MODIFICATION

Sometimes when turning the unit on or off there will be a pop on the subwoofer pre-out

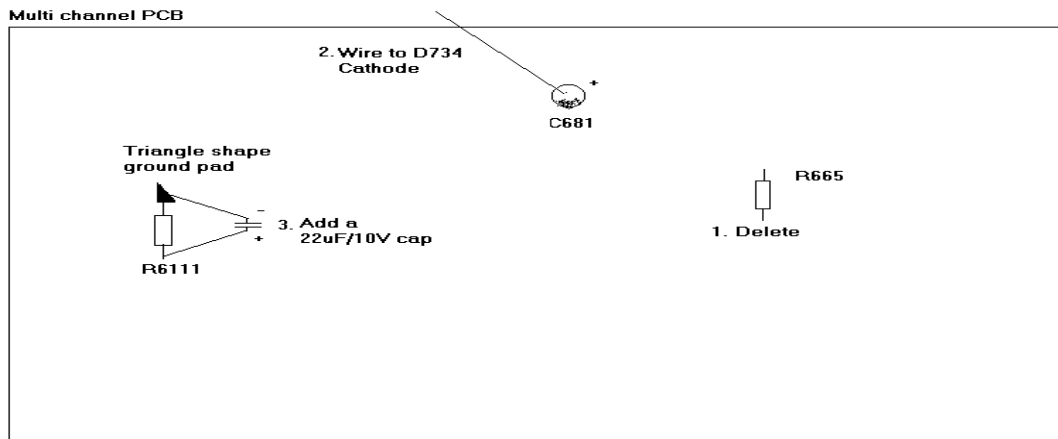
The muting of the subwoofer preamp comes in too late

The following changes, unless otherwise specified, need to be preformed on the multi channel PCB.
Please refer to attached diagram.

1. Remove R665
2. Add a wire between C681 positive pole & D734 cathode side (D734 is located on the main board)
3. Add a 22uF / 10V ce Capacitor over R6111, the negative pole needs to face up.
